Ref : Law Enforcement Academy, Des Moines, IA

Based on our site visit made on the 10th of September 2024 we can inform you as follows.

Cracked boards found on the facade

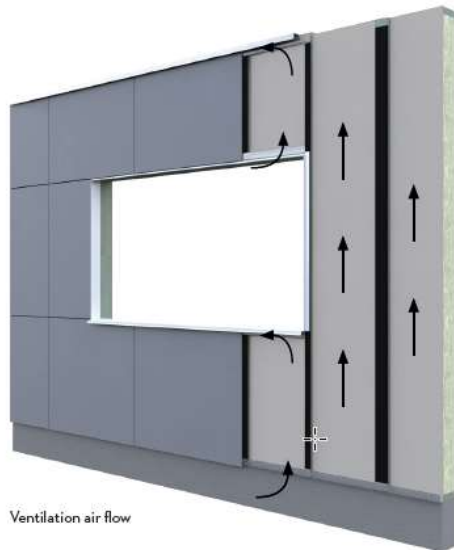
There has been the problem of longitudinal cracks and deformations reported.

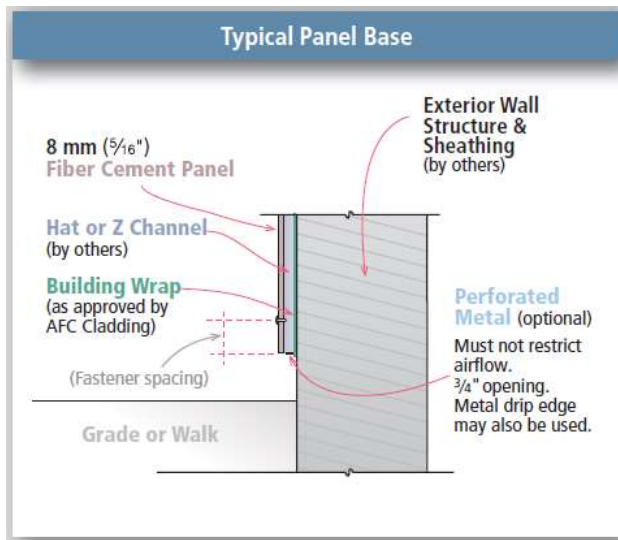
All facades must be designed and constructed as ventilated systems. This requires the provision of an air inlet at the bottom and an air outlet at the top, which applies equally to facade components such as windows and doors. A continuous ventilation gap must be maintained between the backside of the fiber cement boards and the underlying insulation, free from any obstructions.

Upon inspection, it was determined that the façade in question does not meet these ventilation requirements. For all facades incorporating fiber cement boards mounted on a subframe, adequate ventilation is essential. The ventilation principles specific to Swisspearl Patina boards are detailed in the installation manuals provided by our partner, AFCC, which are available on their official website.

To meet the general ventilation requirements, a continuous and unobstructed gap must be present behind the boards. The minimum dimensions for the air inlet and outlet should be at least 3/4 inch.

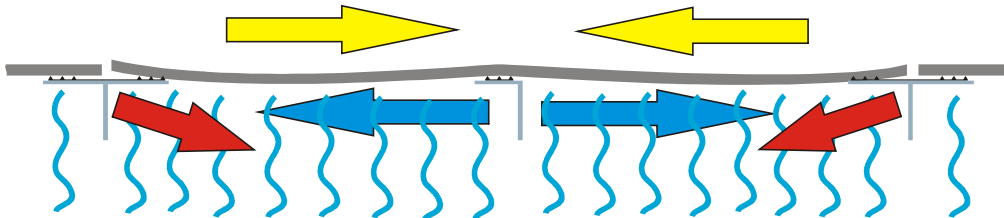
As illustrated in the accompanying image, the top side of the board remains dry and undergoes negative contraction (represented by yellow arrows), leading to shrinkage. Meanwhile, the bottom side remains wet and expands (indicated by blue arrows). This imbalance in moisture levels causes deformation, creating significant tension in the central and edge areas.

These forces become concentrated in the critical areas, which are inherently weakened by pre-drilled holes for mounting, making this region particularly susceptible to cracking. The issue is exacerbated by prolonged exposure to weather, and is most likely to first manifest on façades oriented toward the south and west, which receive the most direct sunlight.

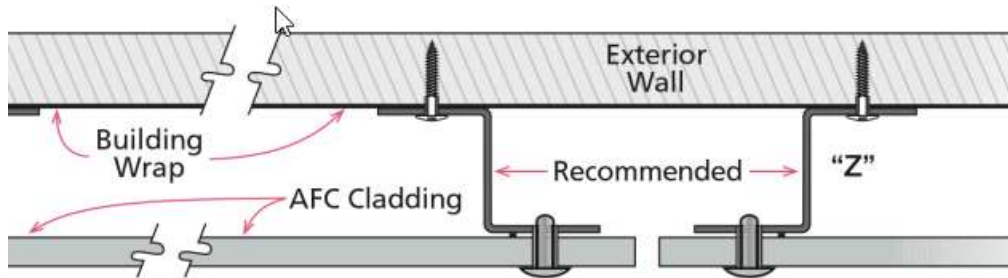
Holes are predrilled only for diameter equal to 8 mm

Too small holes restricted any necessary expansion or contraction movement caused by the natural moisture dilation of fibercement material.

3. Pre-drill holes in panel. Diameter of the fixed and gliding point holes are all 11.1mm (7/16"). Drill bits supplied by AFC.
